RAMP REPORT REGION 2 ADA 2026

Lawerence St., & Ingraham Lane,
Rockland

CR16760

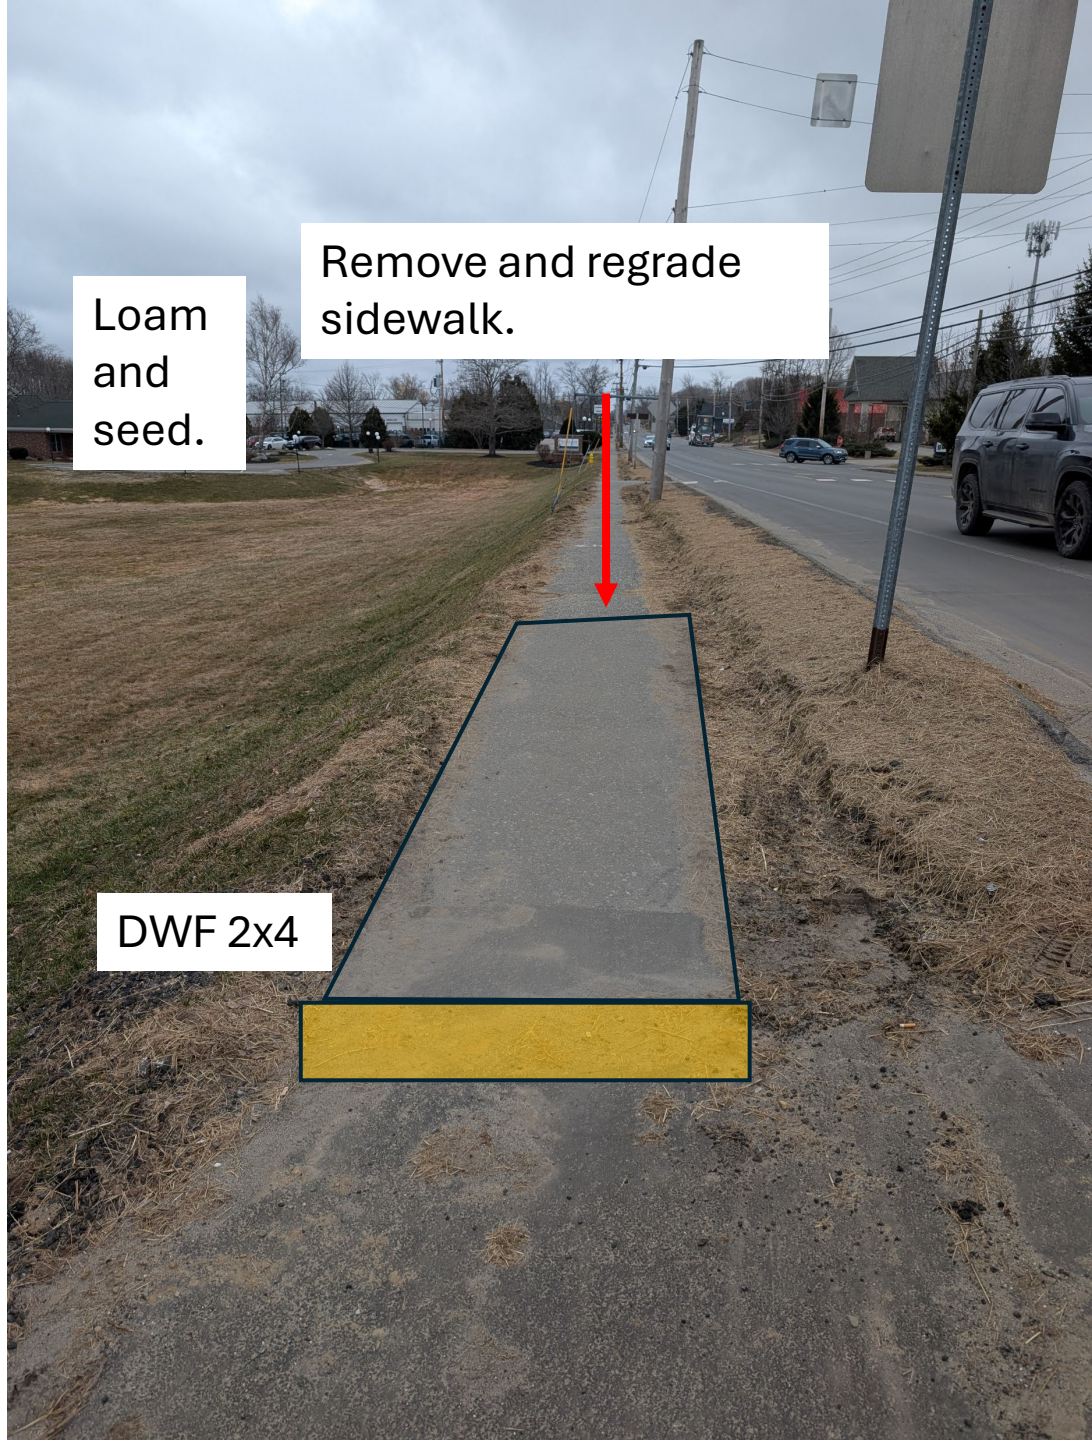
Loam
and
seed.

Remove and regrade
sidewalk.

DWF 2x4

CR04134

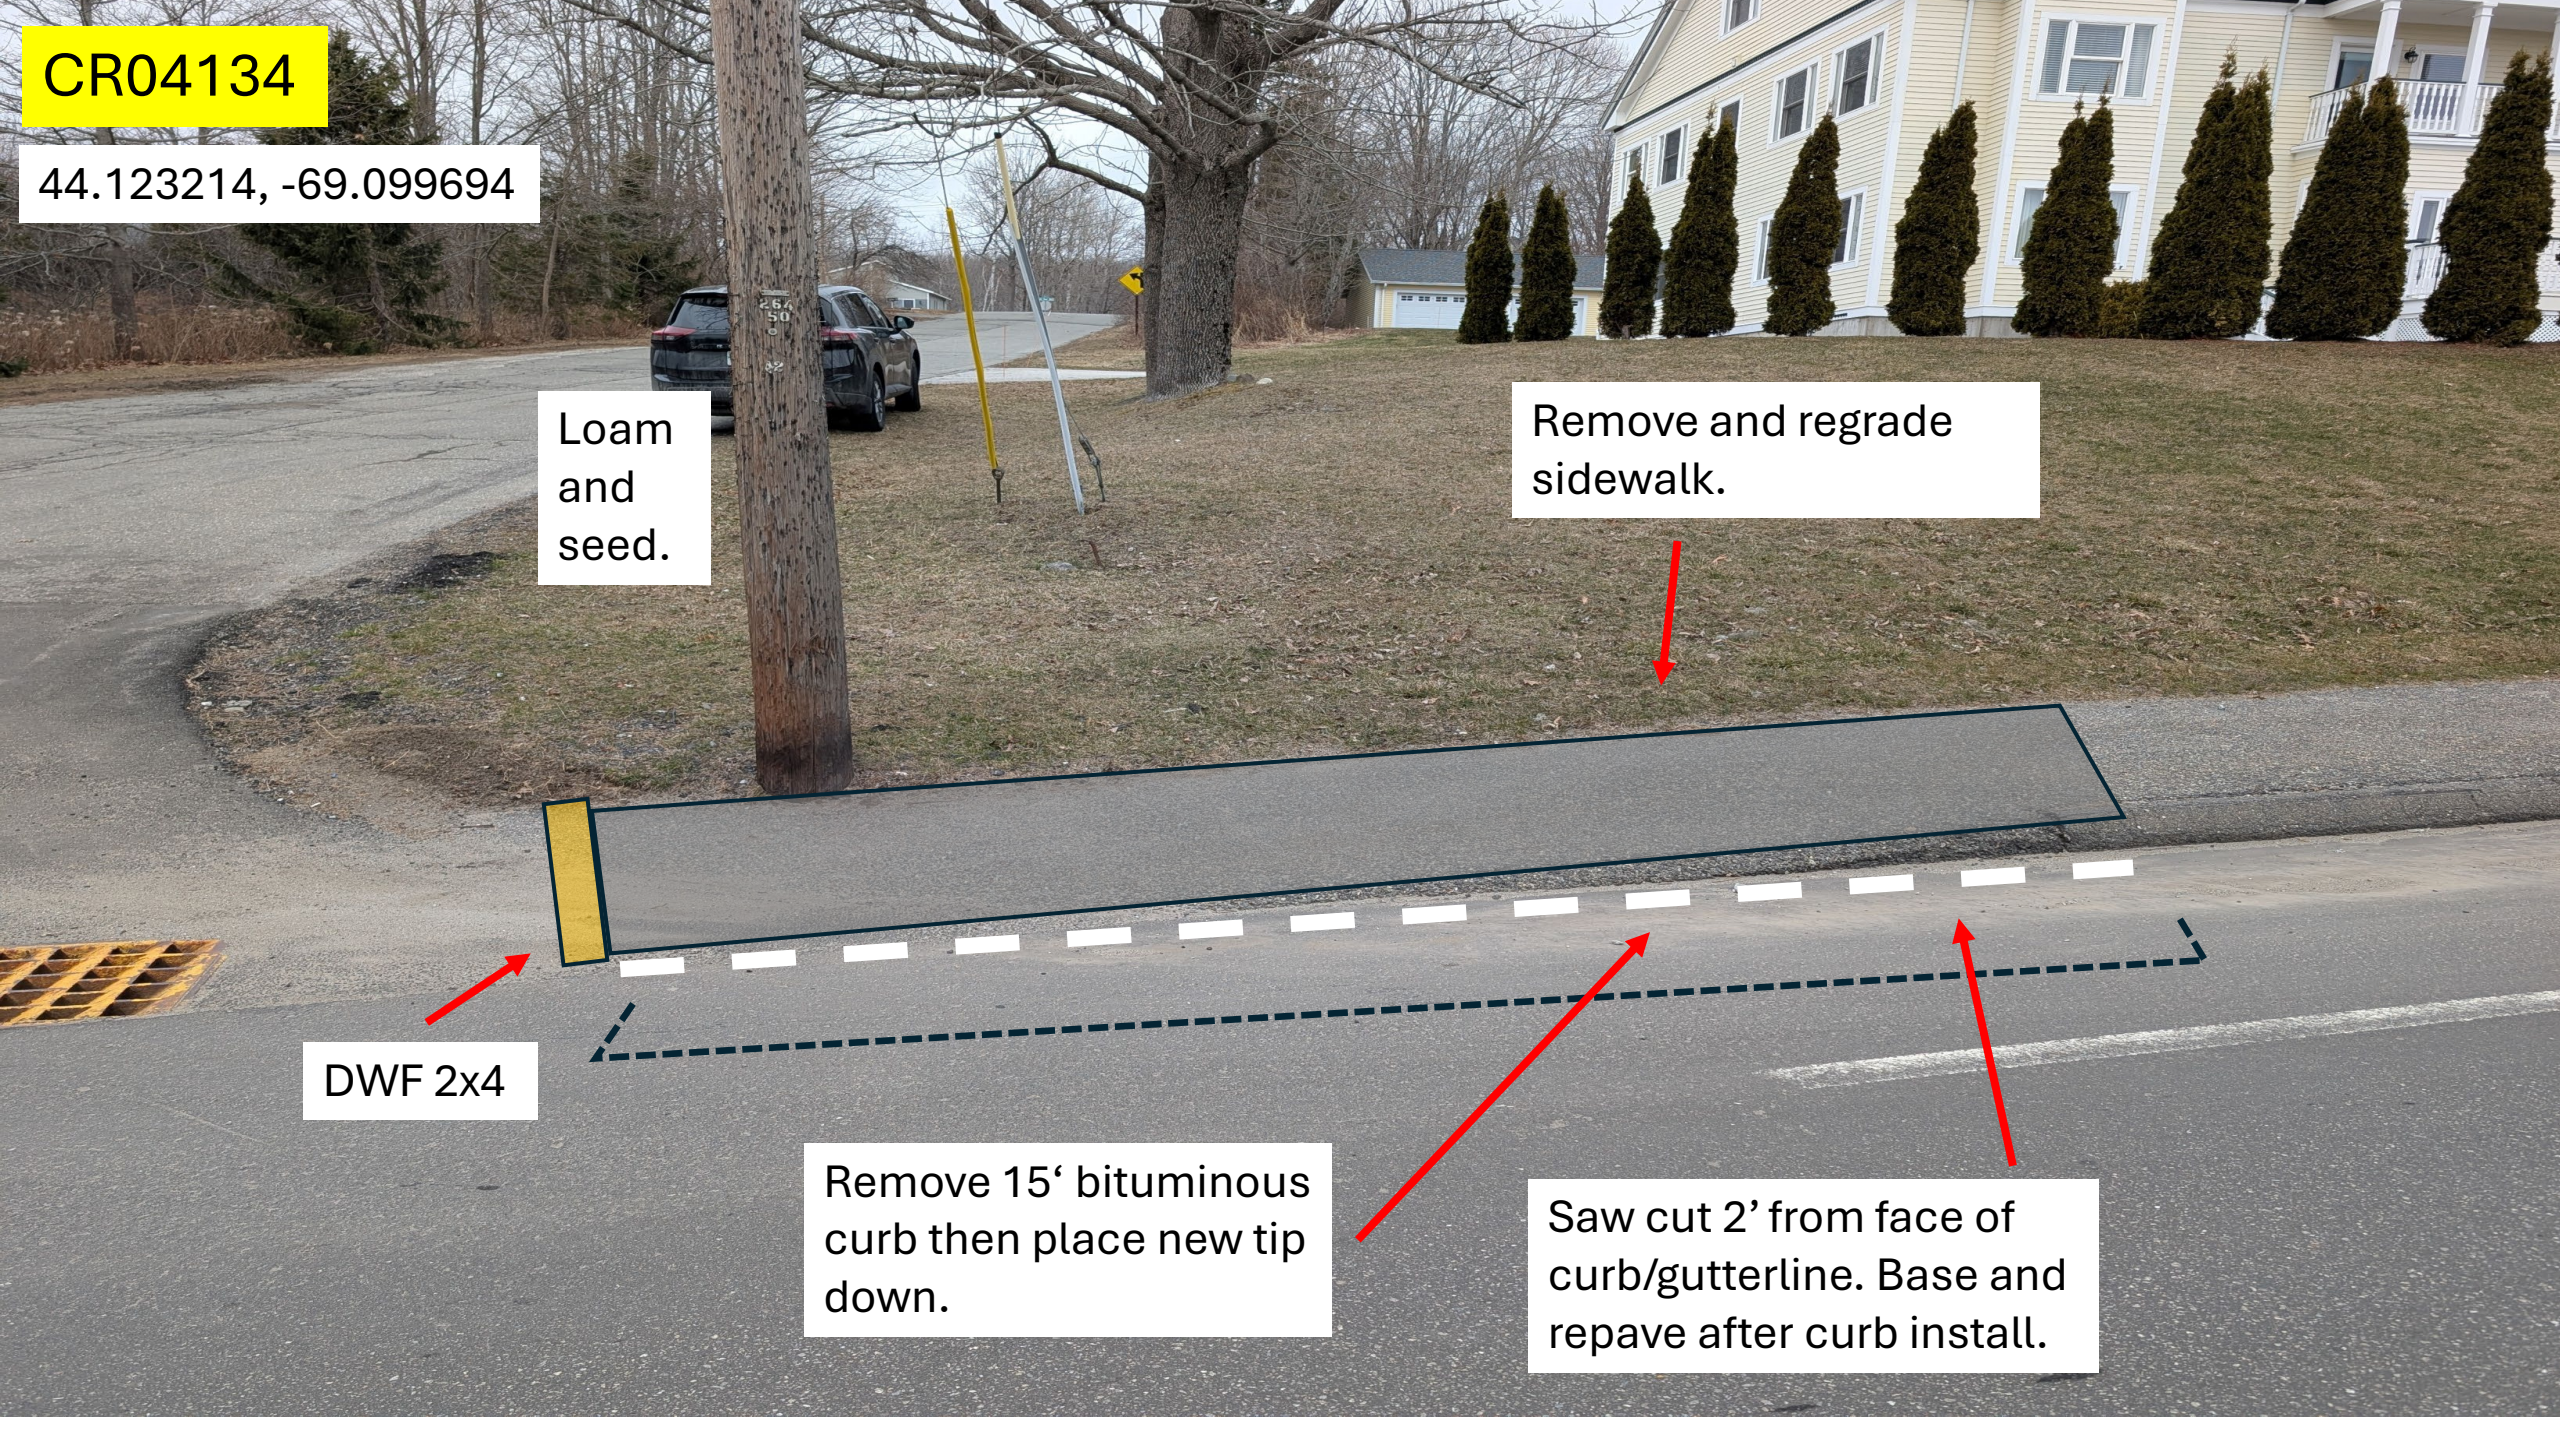
Loam
and
seed.

Remove and regrade
sidewalk.

DWF 2x4

Remove 15' bituminous
curb then place new tip
down.

Saw cut 2' from face of
curb/gutterline. Base and
repave after curb install.

CR04135

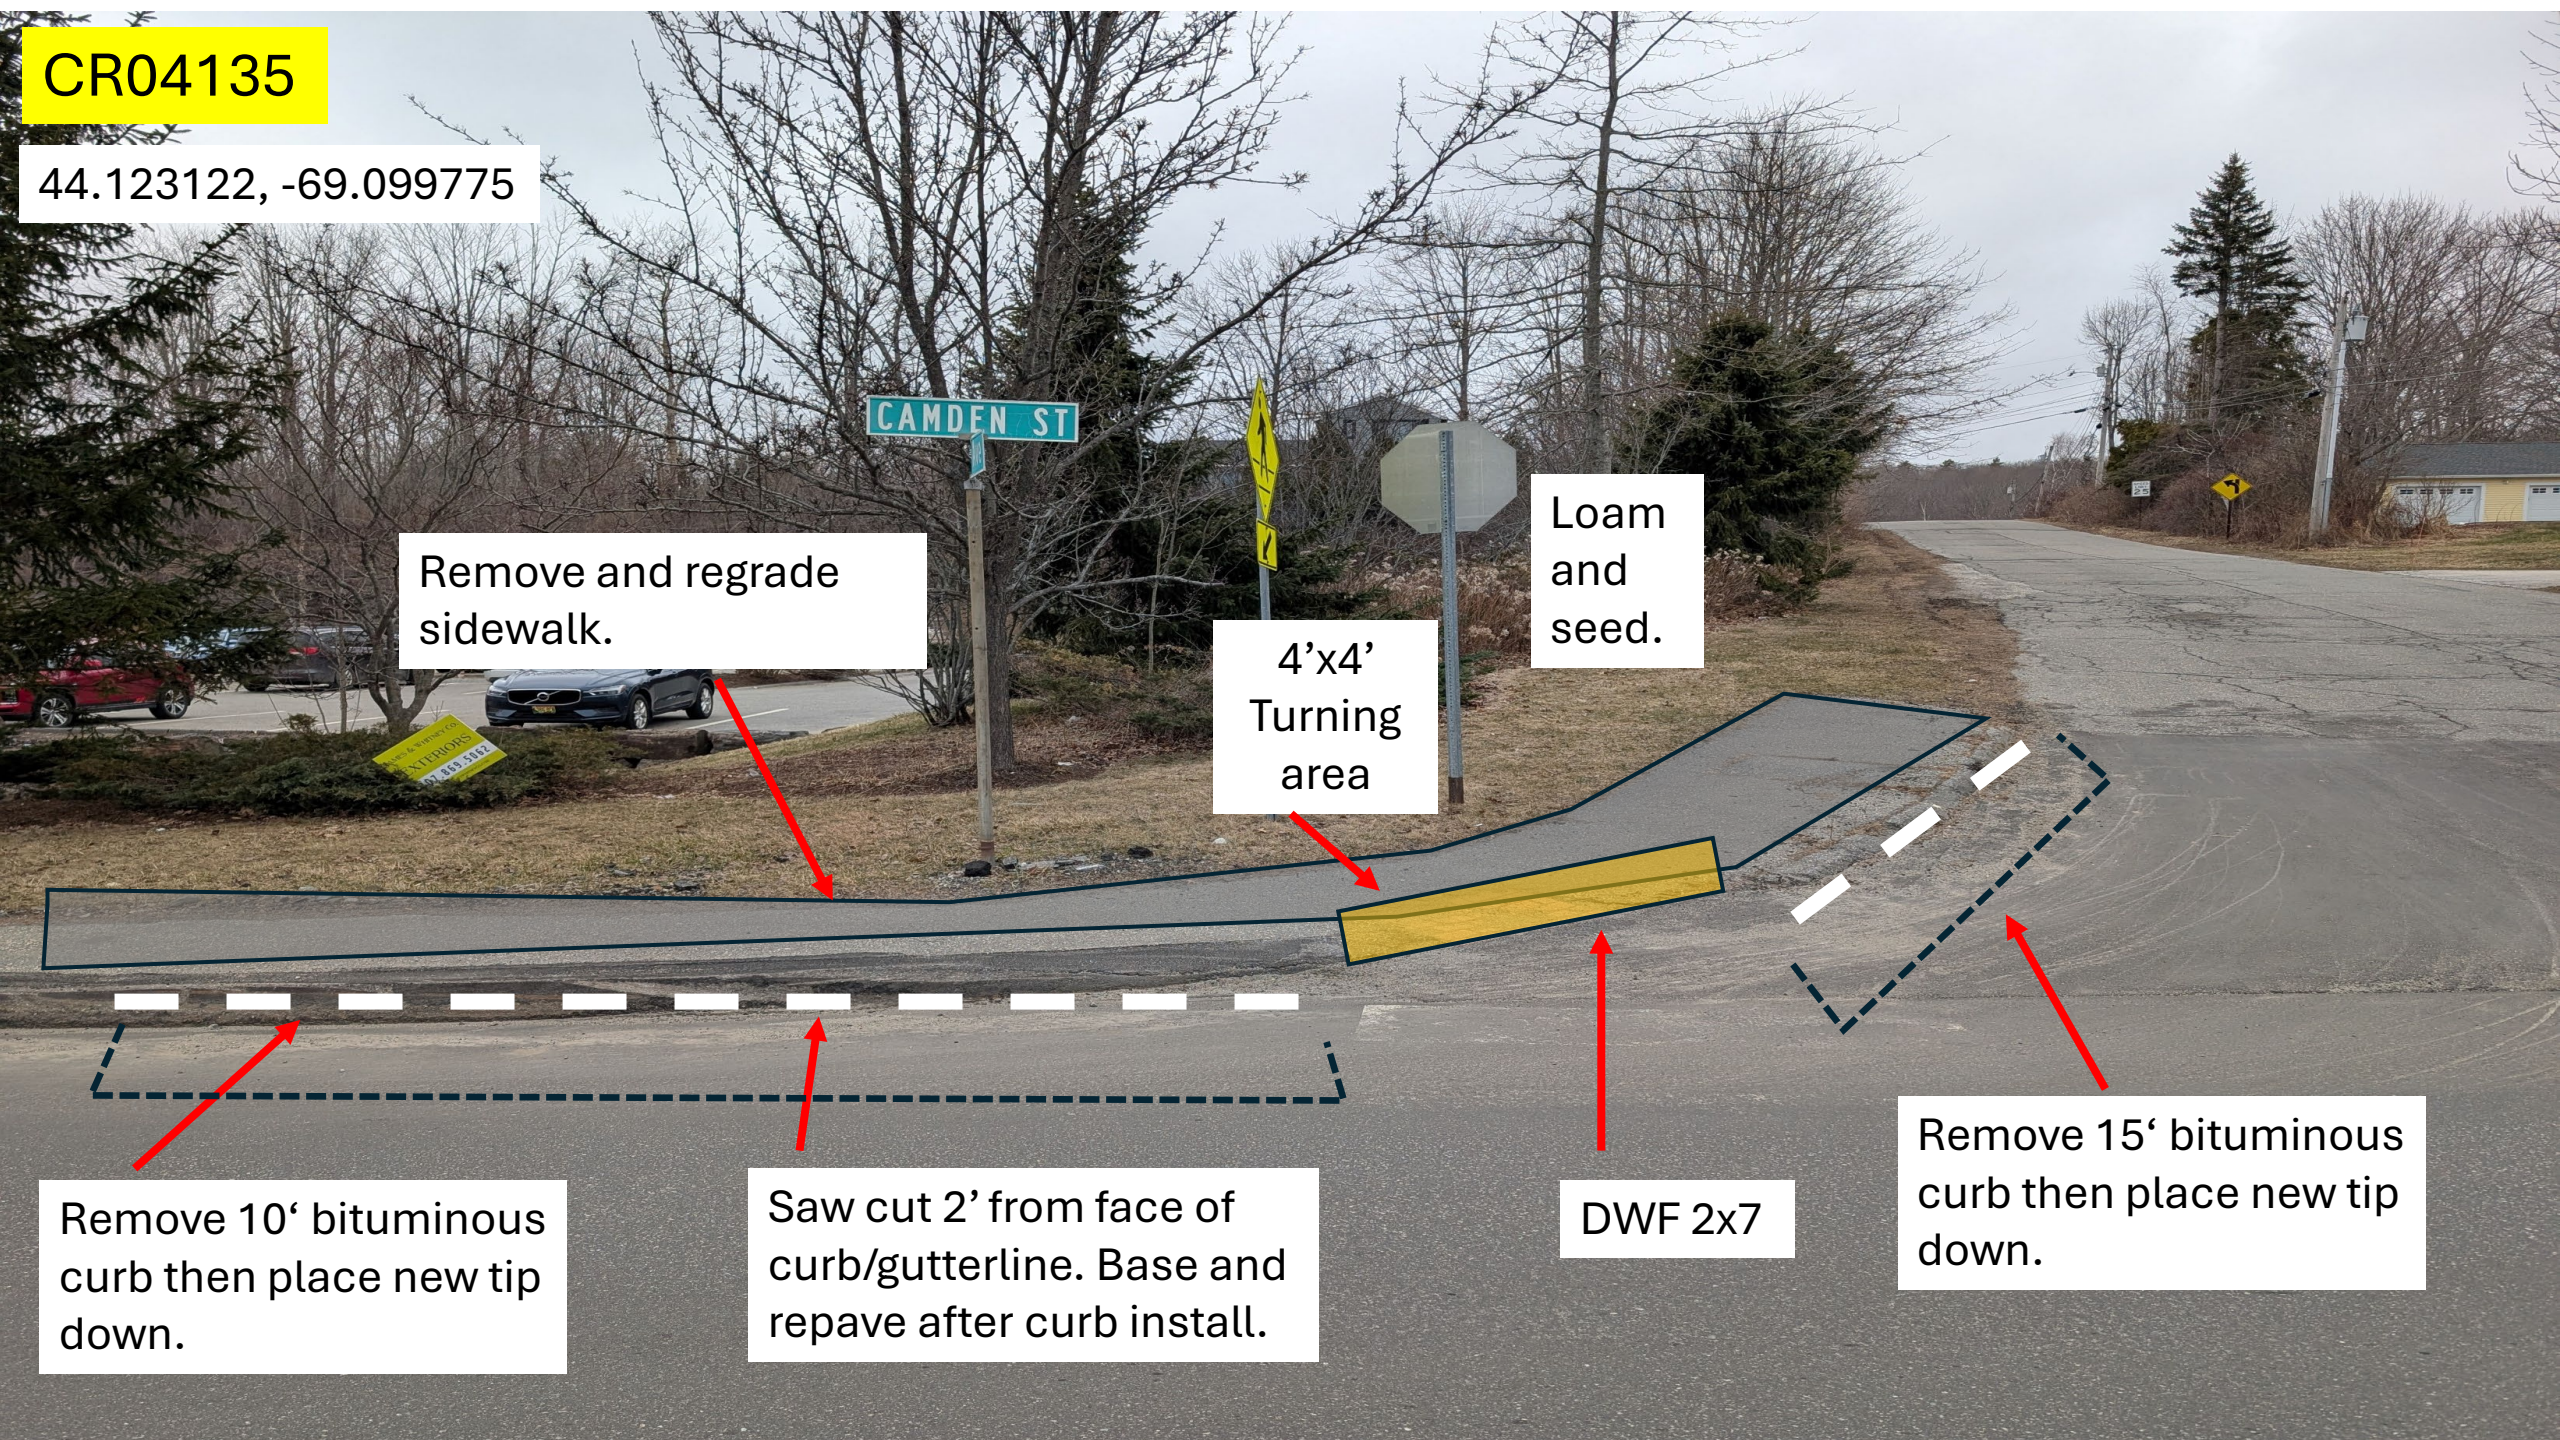
Remove and regrade sidewalk.

4'x4'
Turning
area

Loam
and
seed.

Remove 10' bituminous
curb then place new tip
down.

Saw cut 2' from face of
curb/gutterline. Base and
repave after curb install.

DWF 2x7

Remove 15' bituminous
curb then place new tip
down.
